PLANNING COMMISSION AGENDA
MONDAY, MARCH 28, 2022
CITY HALL at 7:00 PM

To: Spring Lake Park Planning Commission From: Phil Carlson, AICP, Stantec

Re: Conditional Use Permit, Preliminary Plat, Mr. Car Wash, 8200 Central Avenue NE

3-22-22
Based on site plan and landscape
plan by Kimley-Horn; approximate
for discussion

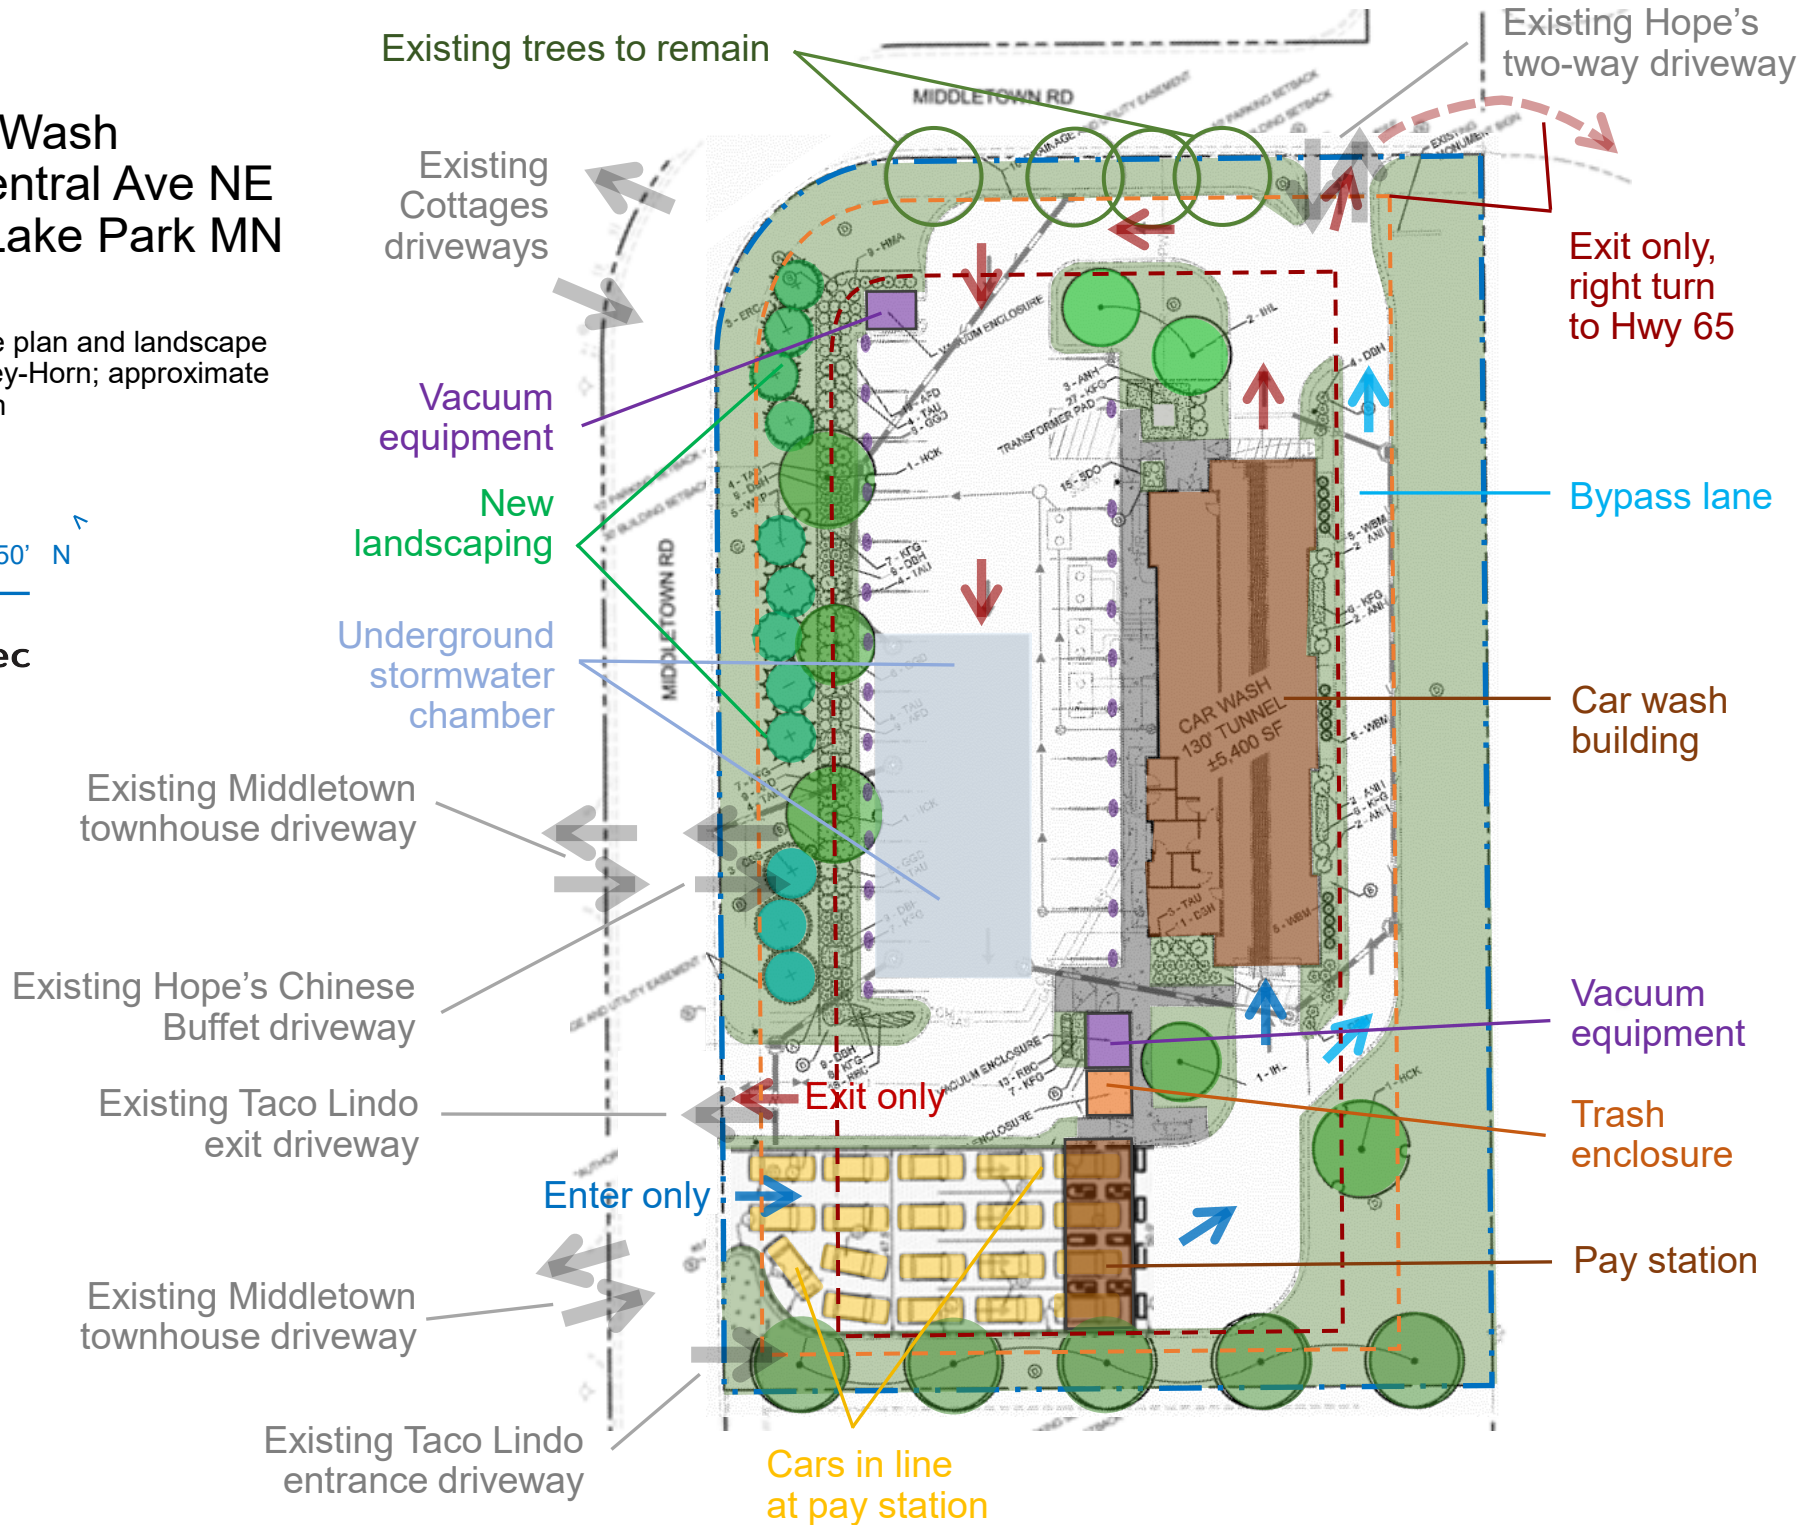
The current two properties have four driveways onto Middletown Road between them – separate entrance and exit driveways for Taco Lindo on the west side of the site, a two-way driveway for Hope's Chinese Buffet on the west side of the site, and a two-way driveway out the north end of the site for Hope's. The proposed Mr. Car Wash plan would replace these four with the three described above. Public works and engineering recommends that the north access drive, proposed as one-way out, be signed to only allow right turns onto Highway 65, and not allow traffic to go straight onto northbound Middletown Road. The existing and proposed driveways are illustrated on the site plan on the next page.

An issue with any drive-through type facility is adequate stacking and making sure that cars waiting in line don't interfere with cars on the adjacent street. The site plan submitted by the applicants shows 19 cars waiting in the pay station lines. This may be adequate, depending on their experience with their facilities. But on a very busy day cars may back up onto Middletown Road, or be tempted to do so. There needs to be clear signage so that stacking onto the road is not allowed and also a condition in the CUP that any traffic problems could result in review and revocation of the permit.

There are 24 parking spaces in front of the building in the parking/vacuum area. This would serve customers and staff for the facility. Spring Lake Park's parking standards require 10 spaces per lane in a commercial car wash. This facility may be different than what was imagined for a "commercial car wash" when the code was written. We recommend relying on the applicants' experience with their facilities to propose adequate parking.

Landscaping & Screening

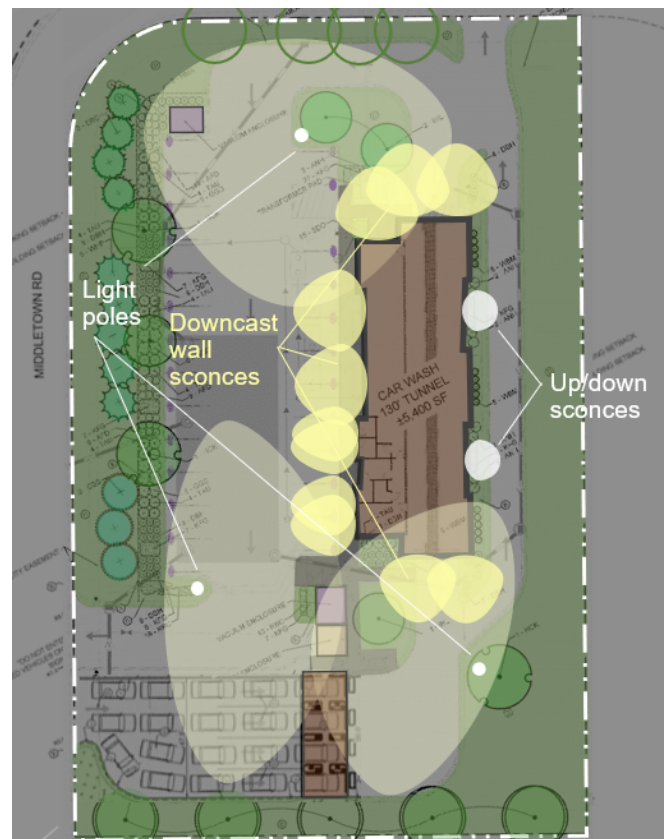
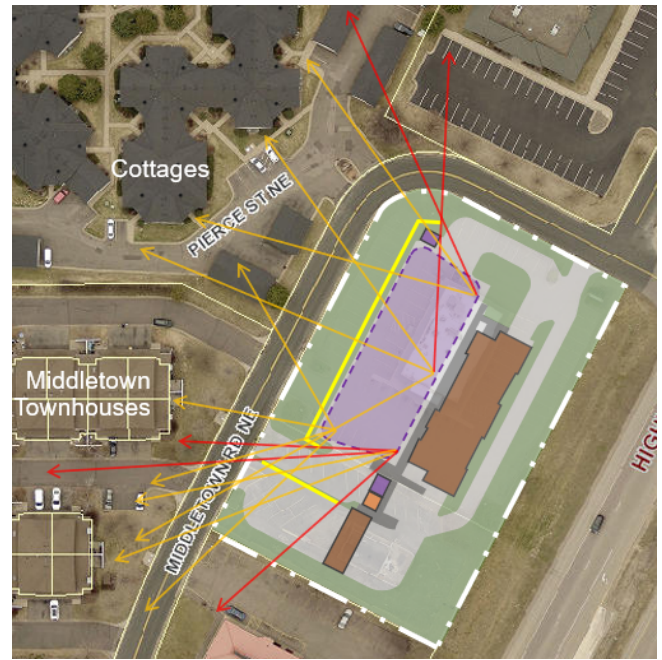
The landscape plan proposes significant landscaping on the west side of the site towards the existing townhouses, consisting of spruce, cedar and pine trees. There are large deciduous trees proposed in other parts of the site and four existing trees on the north side of the site are to be saved. There is a generous and varied complement of shrubs and perennials around the site and building as well.

3-22-22
Based on site plan and landscape
plan by Kimley-Horn; approximate
for discussion

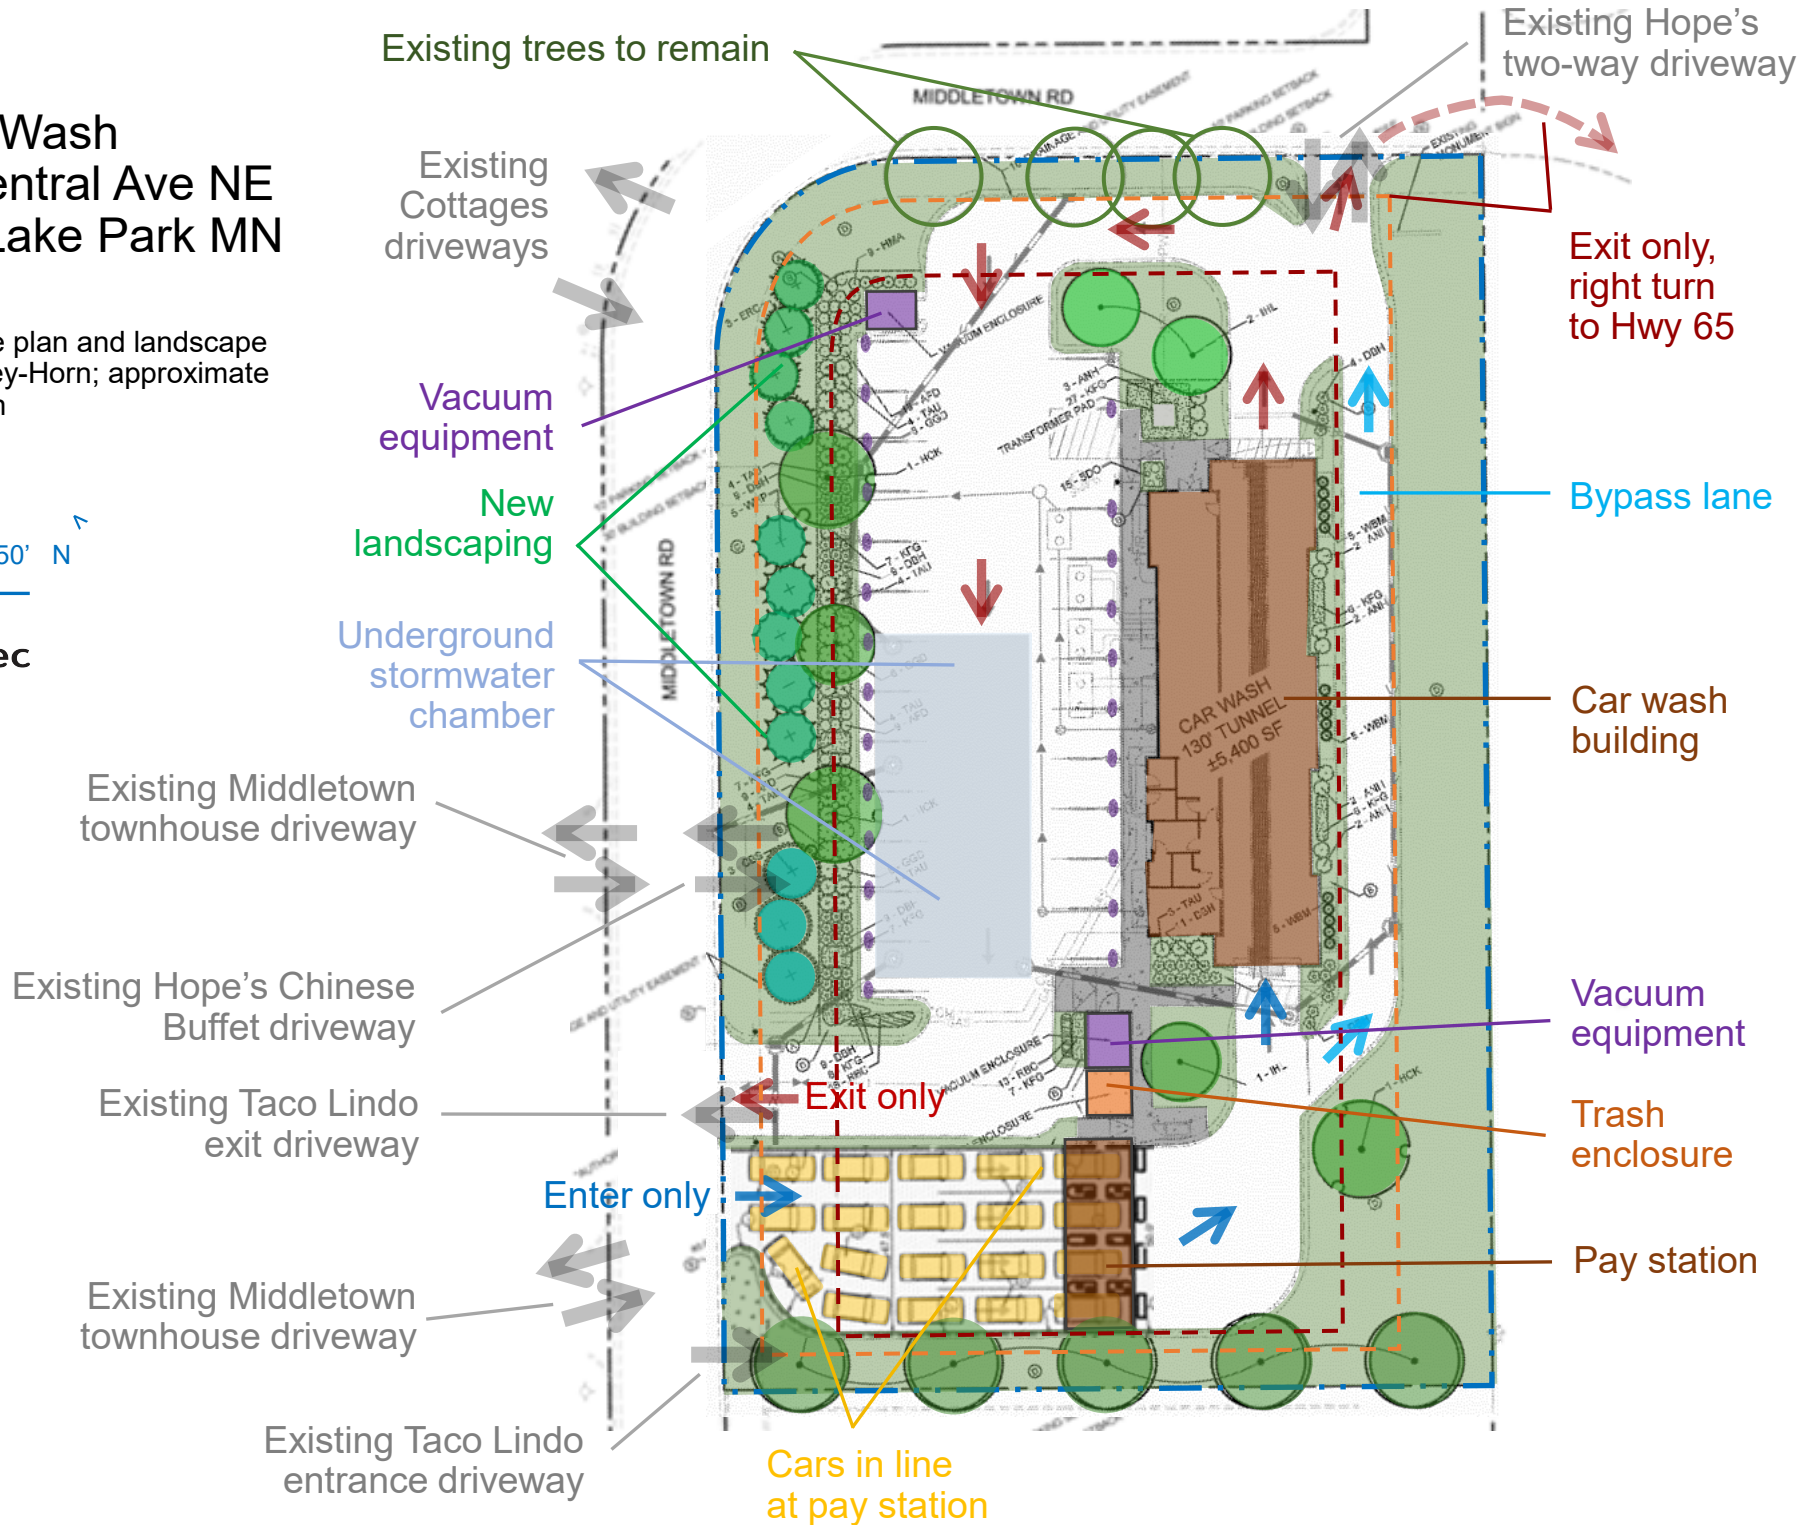
The current two properties have four driveways onto Middletown Road between them – separate entrance and exit driveways for Taco Lindo on the west side of the site, a two-way driveway for Hope's Chinese Buffet on the west side of the site, and a two-way driveway out the north end of the site for Hope's. The proposed Mr. Car Wash plan would replace these four with the three described above. Public works and engineering recommends that the north access drive, proposed as one-way out, be signed to only allow right turns onto Highway 65, and not allow traffic to go straight onto northbound Middletown Road. The existing and proposed driveways are illustrated on the site plan on the next page.

An issue with any drive-through type facility is adequate stacking and making sure that cars waiting in line don't interfere with cars on the adjacent street. The site plan submitted by the applicants shows 19 cars waiting in the pay station lines. This may be adequate, depending on their experience with their facilities. But on a very busy day cars may back up onto Middletown Road, or be tempted to do so. There needs to be clear signage so that stacking onto the road is not allowed and also a condition in the CUP that any traffic problems could result in review and revocation of the permit.

There are 24 parking spaces in front of the building in the parking/vacuum area. This would serve customers and staff for the facility. Spring Lake Park's parking standards require 10 spaces per lane in a commercial car wash. This facility may be different than what was imagined for a "commercial car wash" when the code was written. We recommend relying on the applicants' experience with their facilities to propose adequate parking.

Landscaping & Screening

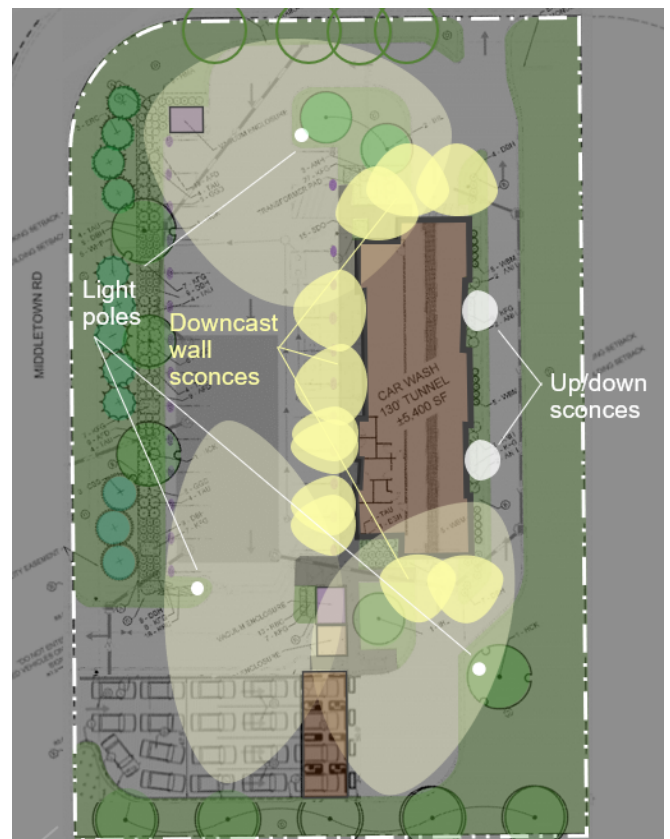
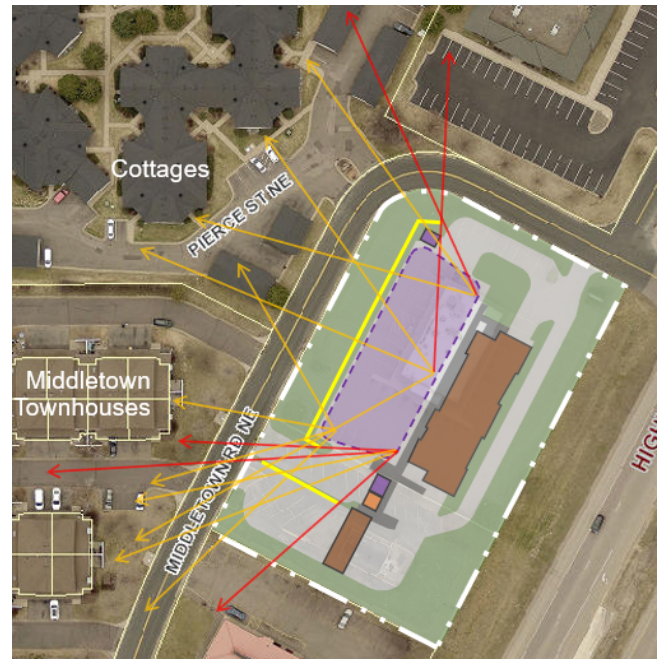
The landscape plan proposes significant landscaping on the west side of the site towards the existing townhouses, consisting of spruce, cedar and pine trees. There are large deciduous trees proposed in other parts of the site and four existing trees on the north side of the site are to be saved. There is a generous and varied complement of shrubs and perennials around the site and building as well.
